Product Change Notice

Date:	March 14, 2023
Overview:	We have changed the screws for the terminal box cover on select AC fans / blowers
Reason for Change:	Design optimization
Affected Part No(s):	Please see part listing on page 2 of this PCN
Design Change Detail:	The Phillips head screw has been replaced by a Torx T20 (Taptide II)
Effective Date:	Running change that began in February of 2023. Depending on existing inventory at ebm-papst Inc. in Farmington, CT, it may take some time for this change to be realized.
Last Time Buy Deadline:	N/A
Pricing:	No change
ebm-papst employee:	Jeannine Zenobi
Attachments:	Affected part numbers and screw design / placement images
Comments:	The screws on the terminal box cover must be removed to connect the wires inside the terminal box, and this change will require a different screwdriver

Screw Design / Placement

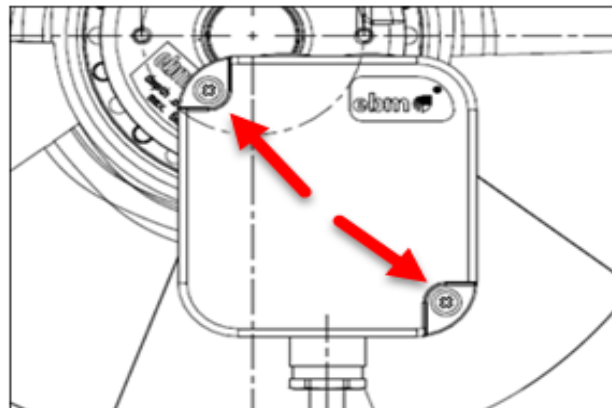
bisheriges Design previous design	zukünftiges Design future design

Kreuzschlitz Cross recess	Torx T20 Taptite II
